TECHNICAL BULLETIN — June 2016

403. Hoerbiger hydraulic cylinders

Issuing Entity:	Bulletin No.: SB-033_02
Vekoma Rides Parts & Services B.V.	Release Date: 16-03-2016
Schaapweg 18	Effective Date: immediately
6063 BA VLODROP	Supersedes: SB-033_01
The Netherlands	Completion Date: 01-01-2017
CoC Number: 12049585

Service Bulletin

Figure 3: information for LE32 and LE25 screw connection at the bottom.

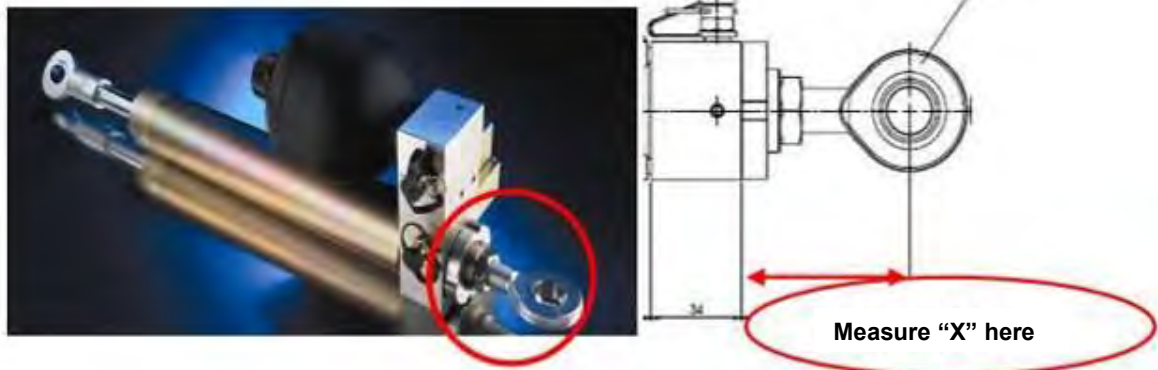
The following data apply for all LE32 versions:

For the LE 32 versions the screw thread depth is correct when the rod end length “X” is below 65 mm. ($X < 65\text{mm}$)

The following data apply for all LE25 versions:

For the LE 25 versions the screw thread depth is correct if the rod end length “X” is below the value as stated behind the product number in de table below. The small x at the end of the product number indicates the version number.

We recommend that the joint rod heads be secured at the specified dimensions and tightened with a torque wrench. The LE 25 version should be tightened to **80 Nm ±10 Nm**. The LE 32 version should be tightened to **90 Nm ±10 Nm**.

The correct measurement must be set and checked when installing or performing maintenance on the Cylinder Accumulator unit. In this way the required minimum screw thread depth engagement (as set out in VDI 2230) is maintained.

This example image is for reference of dimension X only.

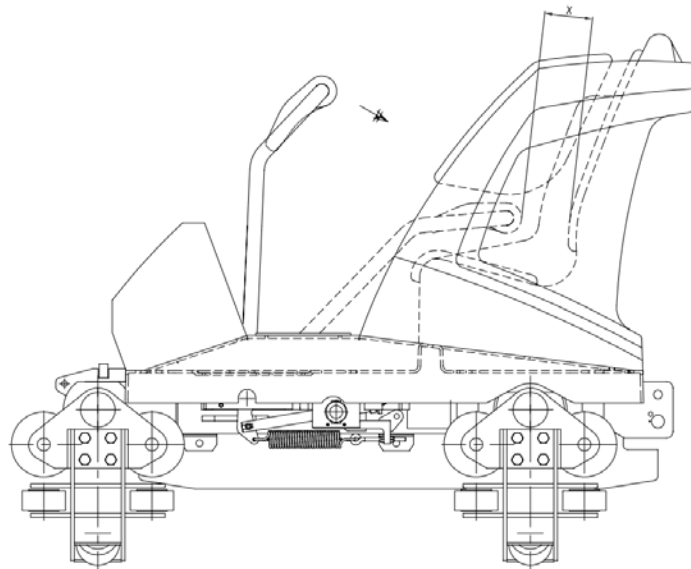
1. Close the restraint, make sure the right hand side HLU is only locking the restraint;
2. Measure the minimal distance (X) between the restraint and the seat (only at start of test);
3. Log this dimension for every seat (only at start of the test);
4. Wait for 10 seconds;
5. Measure the minimal distance (X) between the restraint and the seat;
6. In case this dimension increased by 2 cm the HLU failed and needs to be replaced immediately by a HLU which passed the 1050 cycles;
7. If no dimension change was noticed proceed with step 1;
8. Keep repeating this procedure until 200 cycles have passed the test procedure;
9. Repeat this test and make sure the left hand side HLU is only locking the restraint;
10. After completion of the 200 cycle test for the left and the right HLU it is allowed to take the vehicle in operation.

1. Close the restraint
2. Measure the minimal distance (X) between the restraint and the seat (only at start of test);
3. Log this dimension for every seat (only at start of the test);
4. Wait for 10 seconds;
5. Measure the minimal distance (X) between the restraint and the seat;
6. In case this dimension increased by 2 cm the HLU failed and needs to be replaced immediately by a HLU which passed the 1050 cycles;
7. If no dimension change was noticed proceed with step 1;
8. Keep repeating this procedure until 200 cycles have passed the test procedure;
9. After completion of the 200 cycle test for the single HLU it is allowed to take the vehicle in operation.

The two figures below explain the engraved data and the sticker data on the HLU's. All HLU's manufactured before June 2015 are equipped with a sticker and all HLU's manufactured from June 2015 and beyond are engraved.

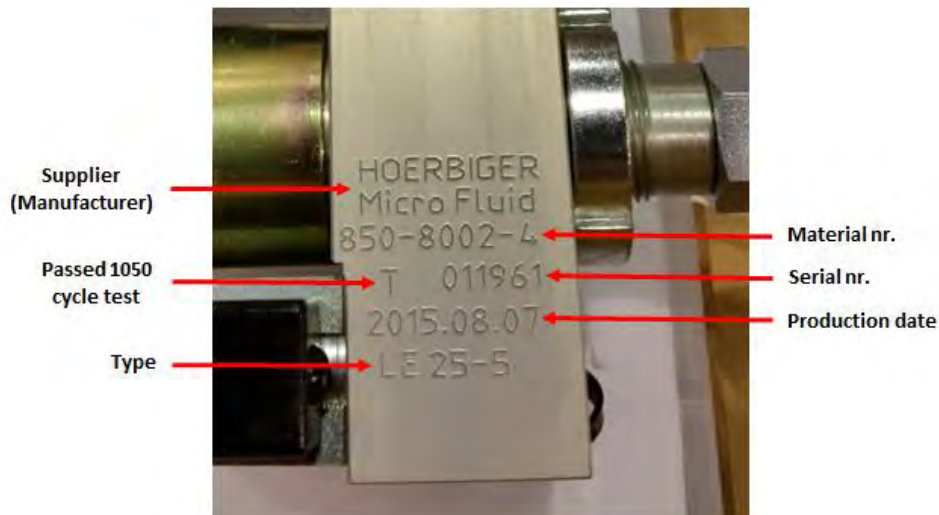
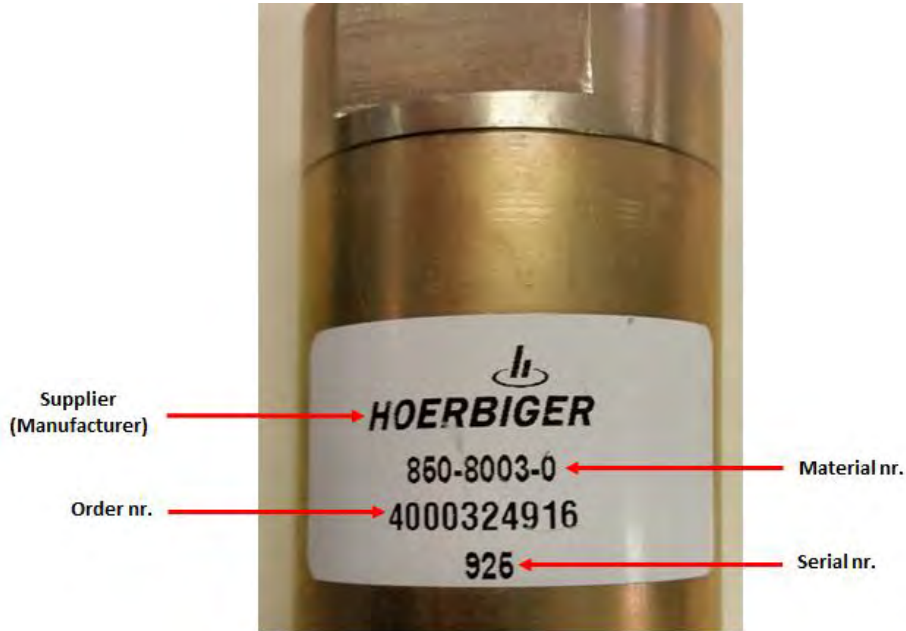
Hoerbiger has released an official statement regarding the lifetime of the HLU's (LE systems). Starting from delivery, LE systems must be replaced with new LE systems within **7 years**.
